PROJECT # 2019-179  
DATE: 28 AUGUST 2020

△ PLAN REVIEW 11.03.2020  
△ PLAN REVIEW 03.19.2021  
△ PLAN REVIEW 05.10.2021

MCKINNEY LANE APARTMENTS PHASE II  
RUSSELL DRIVE & MCKINNEY LANE  
LEBANON, OREGON 97331

△  
 1  
 E2.02  
 BLDG 'D'  
 SECOND FLOOR - LIGHTING PLAN  
 SCALE: 3/16" = 1'-0"

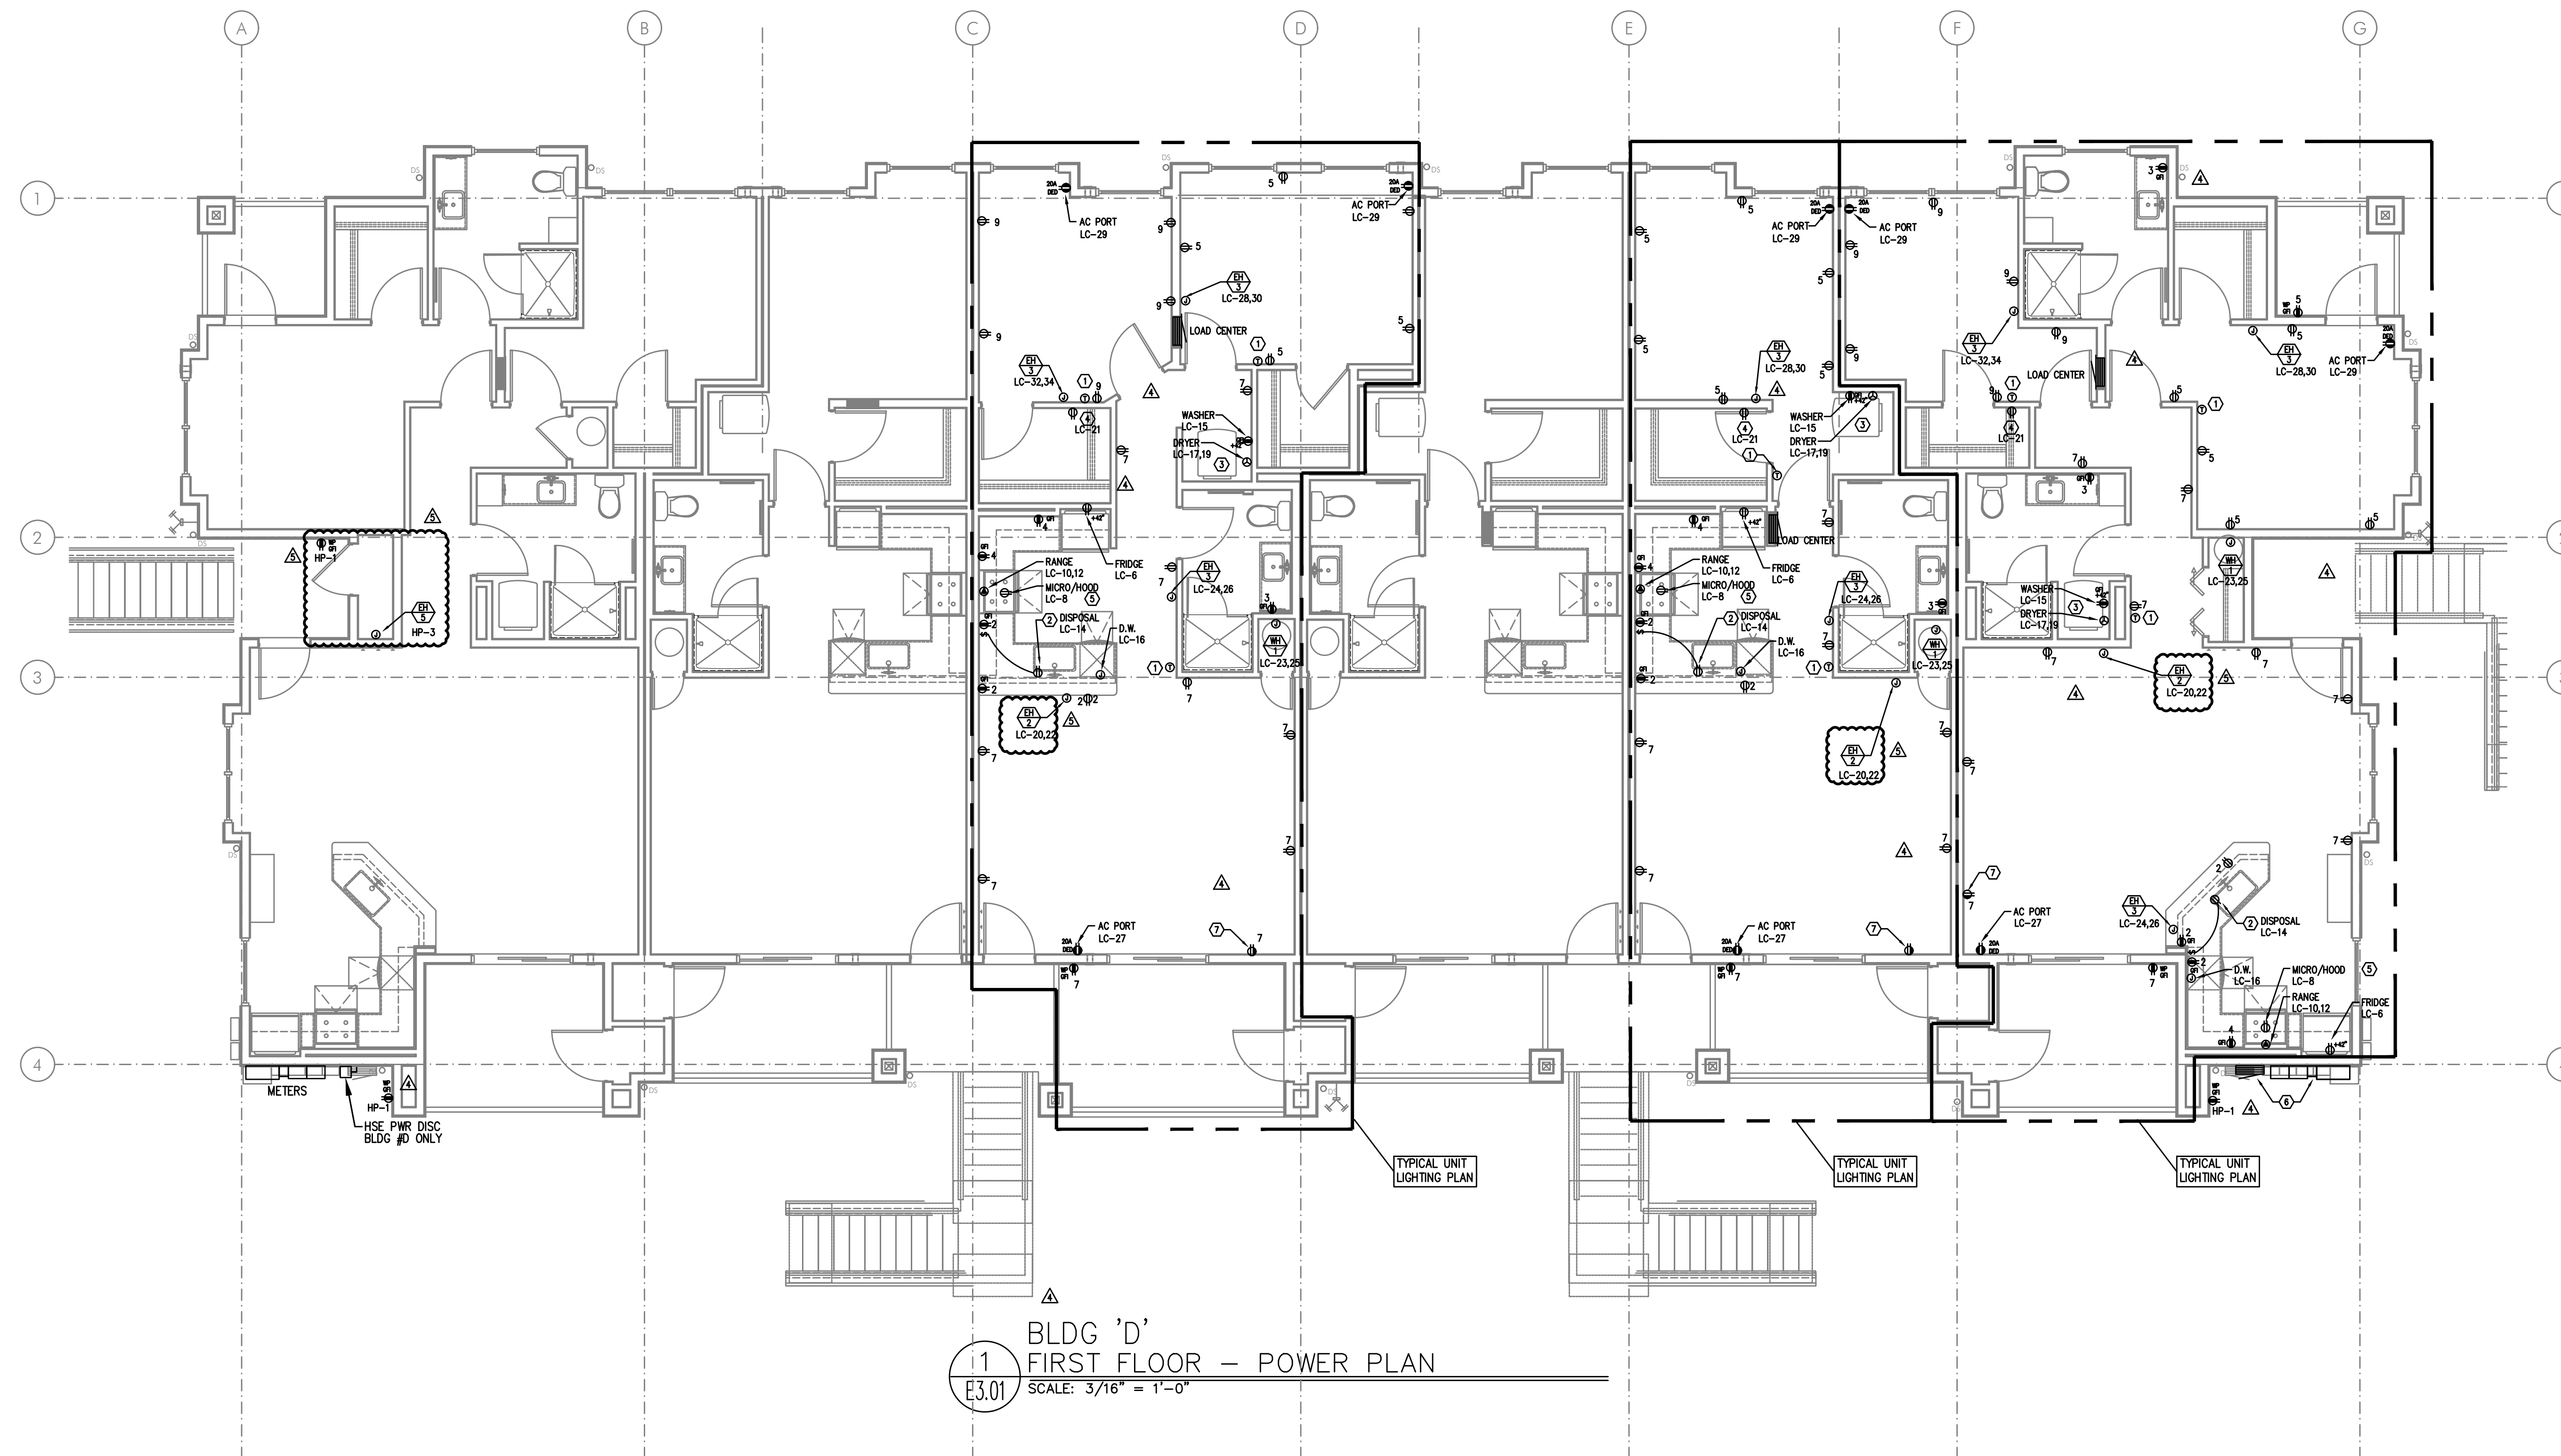
- △ B. ALL DISCREPANCIES SHALL BE BROUGHT TO THE ATTENTION OF THE ARCHITECT IMMEDIATELY UPON DISCOVERY.
- C. REFER TO SHEET E1.21 FOR LIGHT FIXTURE SCHEDULES.

- △ D. THE ELECTRICAL CONTRACTOR SHALL REFER TO THE ARCHITECTURAL AND/OR INTERIORS PLAN SETS FOR DIMENSIONED LOCATIONS, MOUNTING HEIGHTS AND FINISHES OF DEVICES AND FIXTURES.
